Duke Energy

February 22, 2001

Subject: Oconee Nuclear Station
Docket 50-269, -270, -287
Selected Licensee Commitments Manual (SLC)

Subject: Oconee Selected Licensee Commitments Manual (SLC)
Revision

Figure 16.8.4-1
Keowee Operational Restrictions

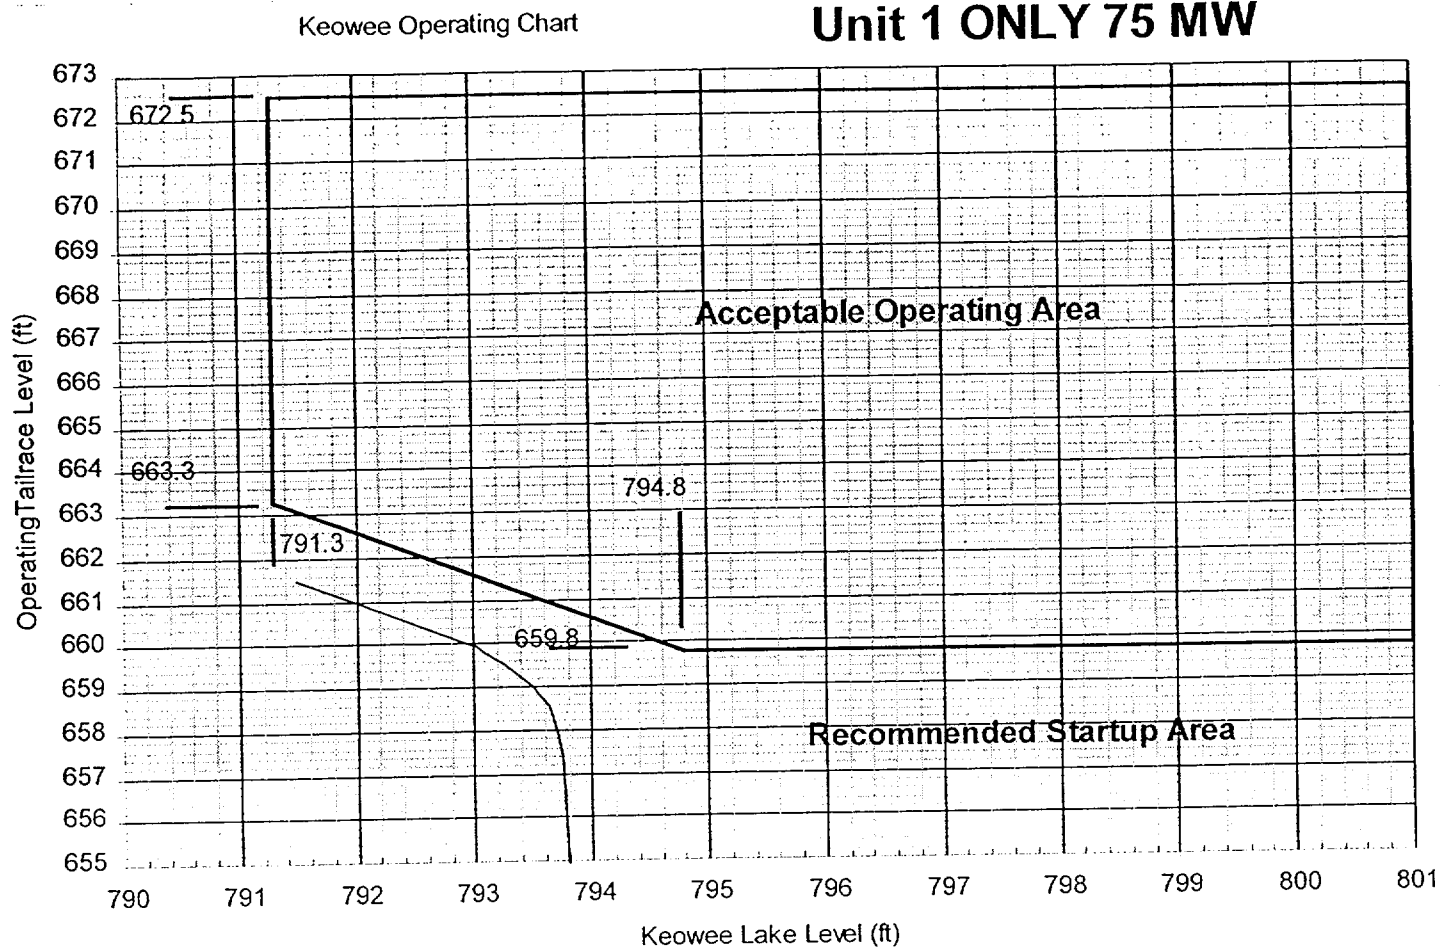
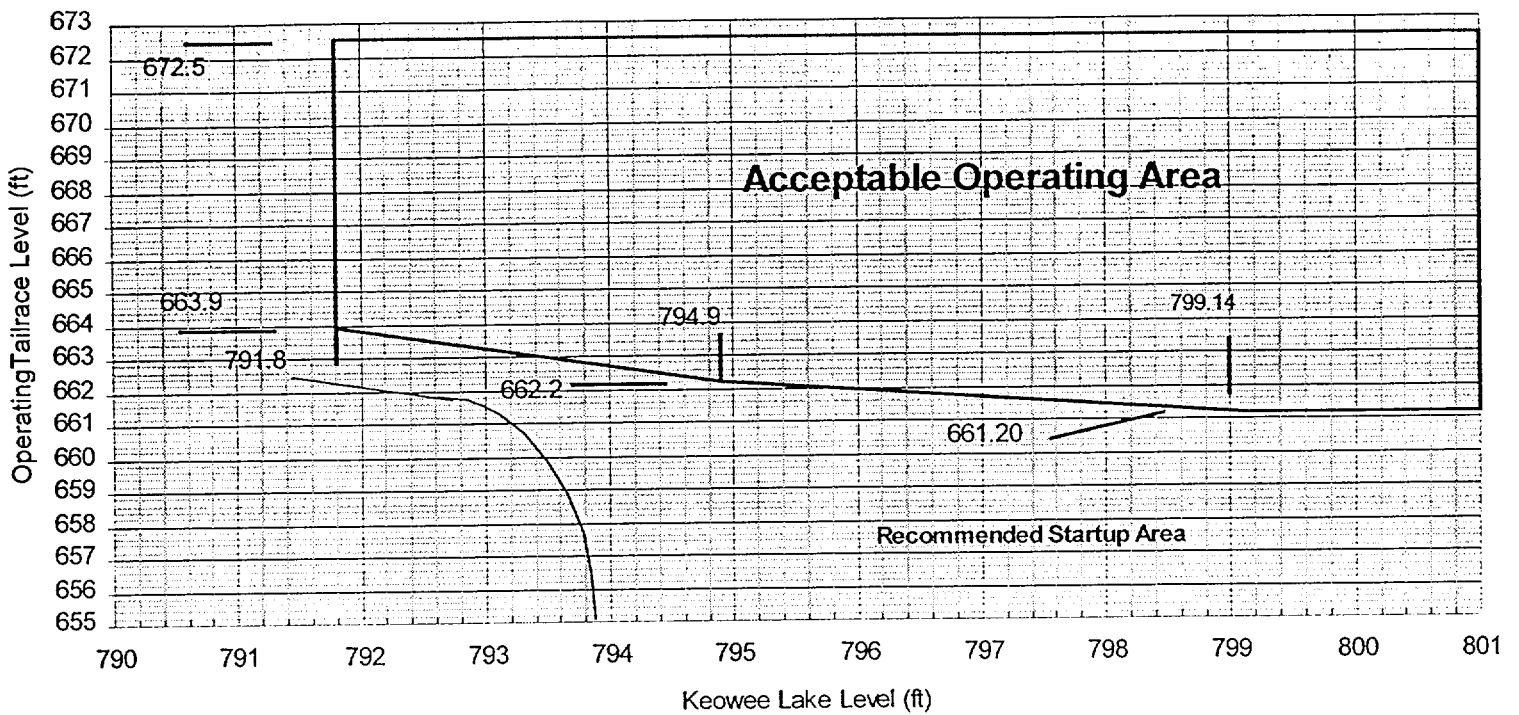
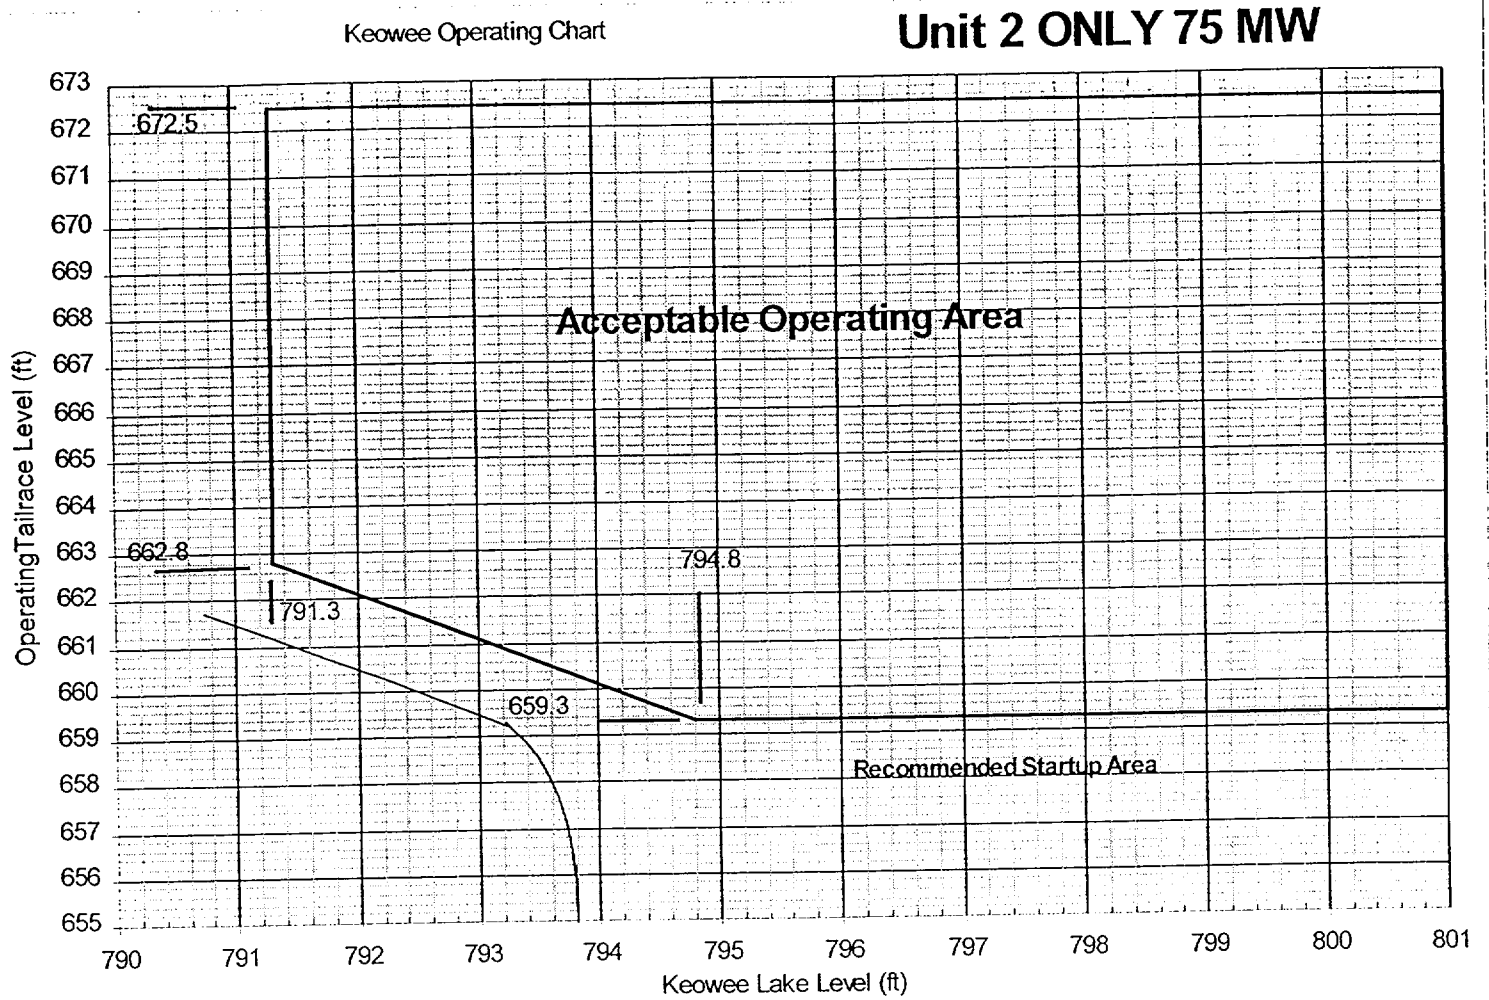
Likewise, on February 15, 2001, Station Management approved a revision to SLC 16.8.4, which was implemented on February 15, 2001. This change revised the figures of SLC 16.8.4, Keowee Operational Restrictions, to increase the Keowee Unit 1, Unit 2 and dual Unit operating envelopes in terms of recommended start-up lake levels.

Each figure has a recommended start-up area. This gives the Operator guidance on forebay and tailrace levels from which an idle Keowee unit can be started with assurance that the Acceptable Operating Area will be attained when the unit is generating. An engineering evaluation must be made prior to starting the Keowee Units when forebay and tailrace levels are outside the recommended start-up range.
